South Texas Project Electric Generating Station P.O. Box 289 Wadsworth, Texas 77483

January 6, 2010  
U7-C-STP-NRC-110006

South Texas Project  
Units 3 and 4  
Docket Nos. 52-012 and 52-013  
Response to Request for Additional Information

RAI 04.04-4

**Figure 6C-1 Schematic of Cassette Type Suction Strainer**

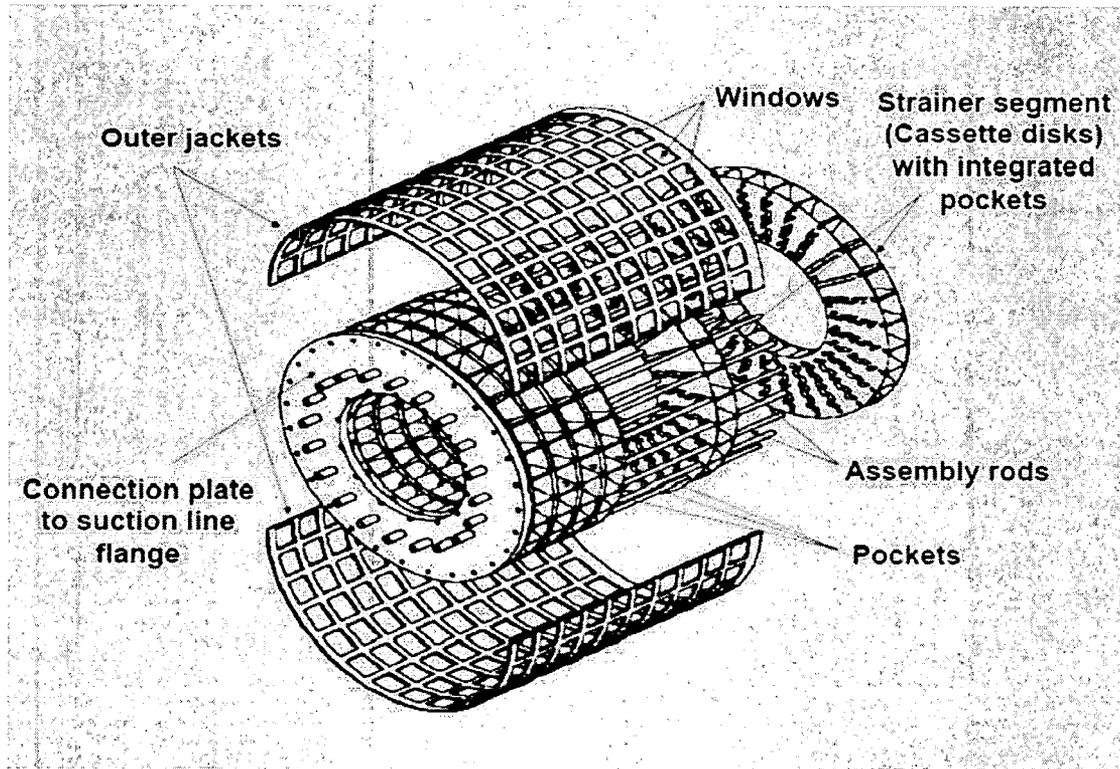
STD DEP 6C-1 (Figure 6C-1, ~~6C-2, 6C-3, 6C-4, and 6C-5~~)

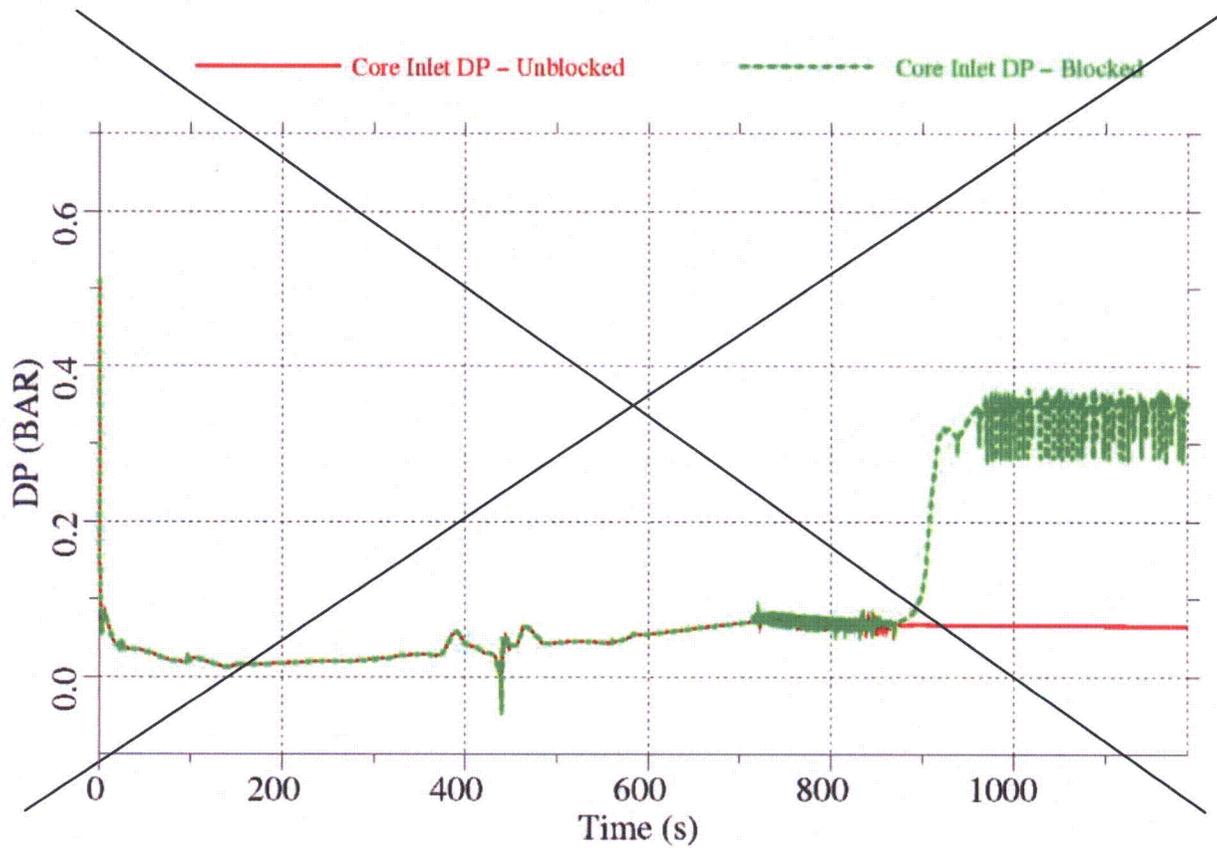
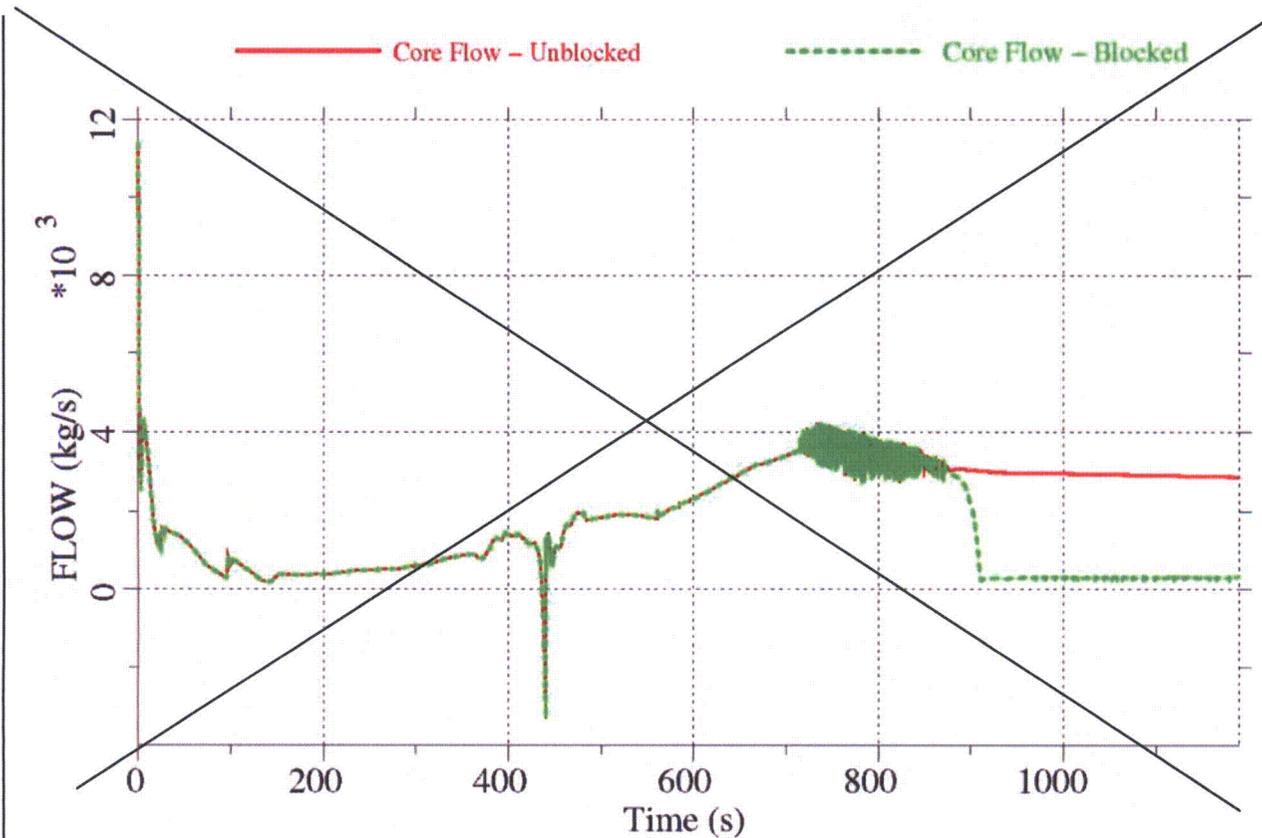
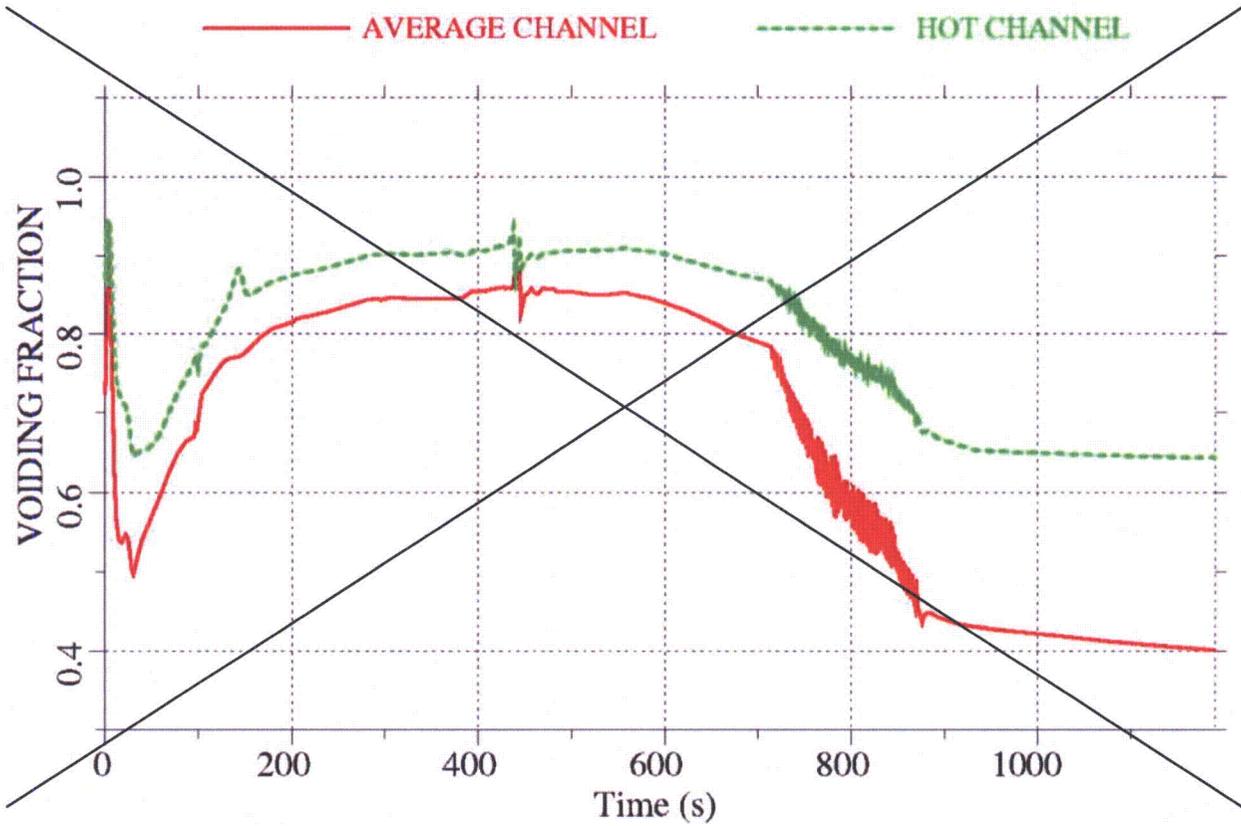
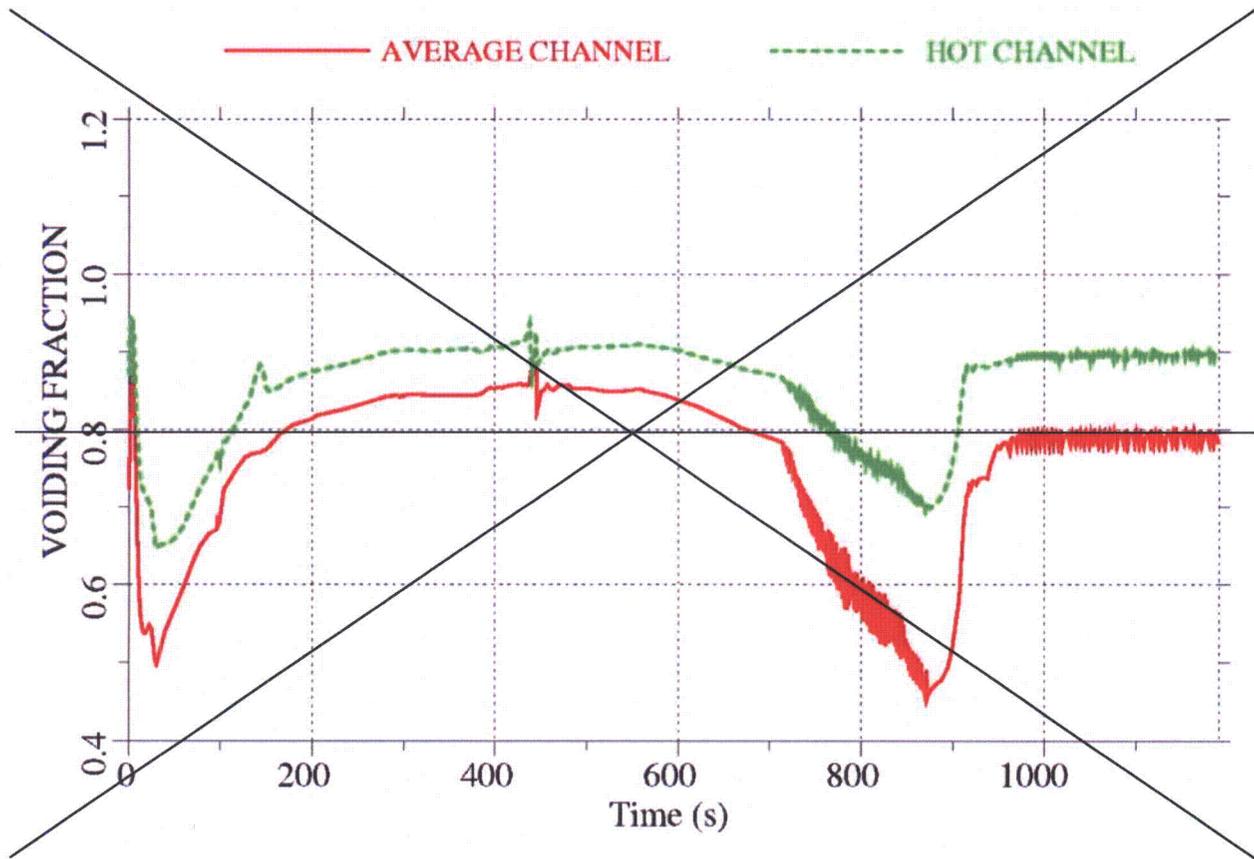
During the NRC staff audit (held on July 12, 2010) of the calculations supporting the downstream fuel effects test acceptance criterion of 5.076 psid (U7-C-STP-NRC-100044 dated February 22, 2010), the staff discovered that the calculations were based on Optima II fuel rather than the GE-7 fuel approved in the ABWR DCD. Explain how the proposed criterion is suitable for the fuel design that is currently the basis for the ABWR design.

Figures 6C-2, 6C-3, and 6C-4 An analysis was performed to compare the core inlet DP, flow rate and void fractions for the cases with no blockage and with blockage resulting in a reduction of flow area by 90% of inlet flow area an increase of the hydraulic resistance of the fuel inlet. Five minutes is the estimated amount of time required for debris in the containment to start to reach the fuel filters. The models assume clogging begins at 850 seconds because that is when the flow through the core reaches steady state. In order to ensure any effects seen are covered by the changes being made, steady state flow is required. The analysis results demonstrate that, despite a very high level of blockage hydraulic resistance, sufficient flow remains available to the core to ensure that the core void fraction both in the hot assembly and average assembly remain  $< 0.95$ .
